Work Order ID 64741

Item Name: Spacepod, LH, AS350

PULL FROM STOCK:
1 X D350-600-141 B 43215
REWORK TO MAKE D350-600-241
PER IIN-D350-600 REV.E
SECTION 3.4

From: David Shepherd <dshepherd@dartaero.com>
Sent: January 17, 2011 6:34 PM
To: 'Chris Provencal'
Cc: 'Mike Petsche'
Subject: RE: D350-600 Spacepod door deviation

FIGURE 13(a) – D3186-1 SPACEPOD™ DOOR COMPOSITE MODIFICATION
(APPLICABLE FOR -041/-043/-141/-143 KITS)

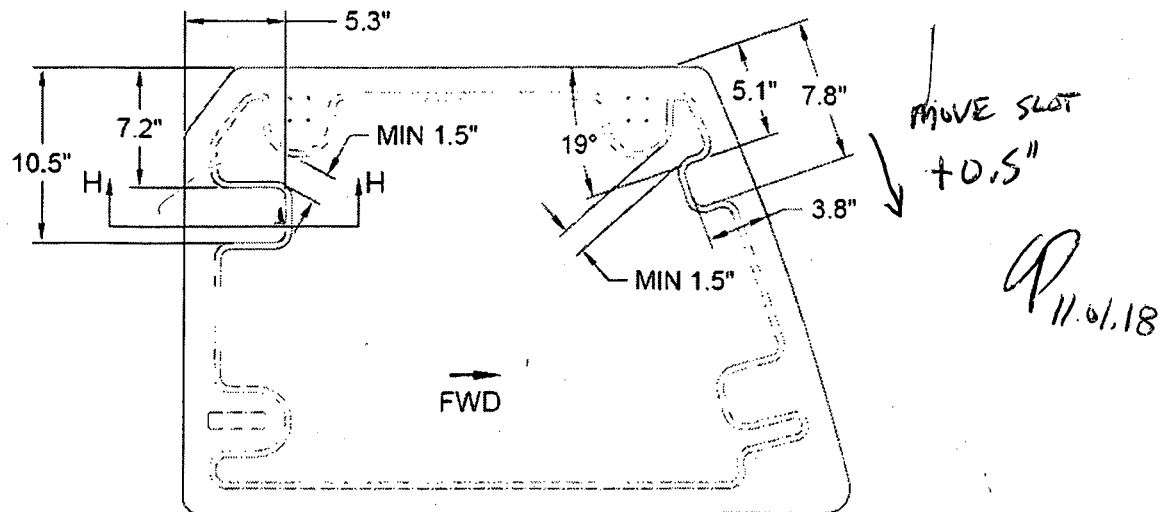
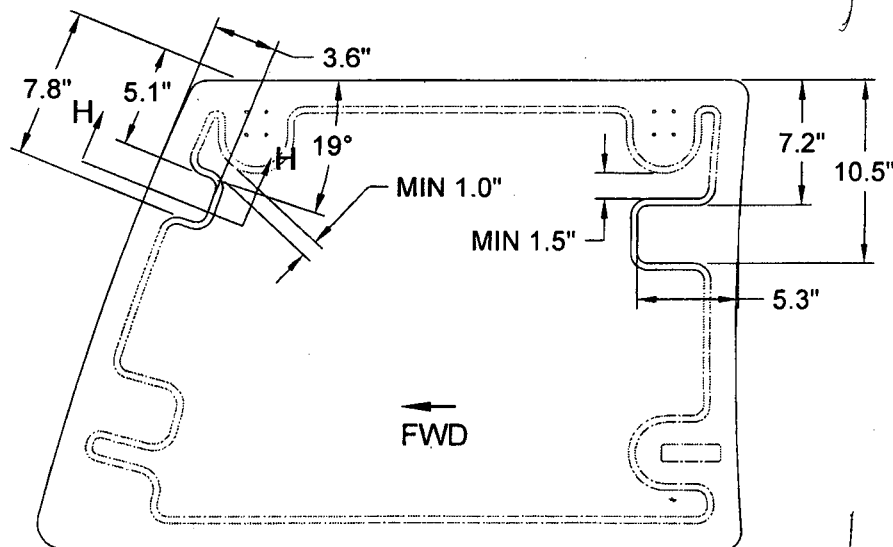
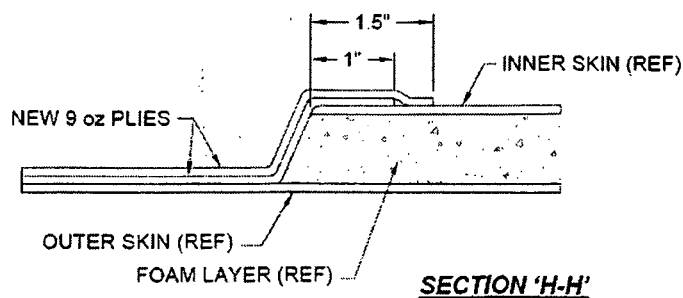
W/O:		WORK ORDER CHANGES						
DATE	STEP	PROCEDURE CHANGE	By	Date	Qty	Approval Chief Eng / Prod Mgr	Approval QC Inspector	
11.01.18	110	<div>CP11.01.18</div> <div>LOCATE FWD-TOP ^{HINGE} LATCH LOCATION 0.5" LOWER. TO ENSURE 1/5 MIN FORM. REF DS EMAIL</div>				<div>CP</div> <div>11.01.18</div> <div>DS/042</div>		
11-01-18	110	<div>spaced D-350-600-141 in short 1 D 2228 bumper plate</div> <div>D 2228 B <u>48228</u></div>	BT	11-01-18

They are reworking an old spacepod door to install an additional latch on the leading edge. If Ian cuts foam at the location specified (ref pg 17 on IIN), there will only be 1" of foam between the hinge and latch, while the drawing calls for 1.5" min. This is due to the cut-outs for the hinges, which were larger on old doors. We could add an additional layer of cloth on the inside to strengthen it.

If this is not acceptable, I could alternately have him install the latch 0.5" lower on the door.

Both scenarios decrease the strength of the door, so I don't have authority to accept either.

My recommendation would be to drop the hinge 0.5" lower.
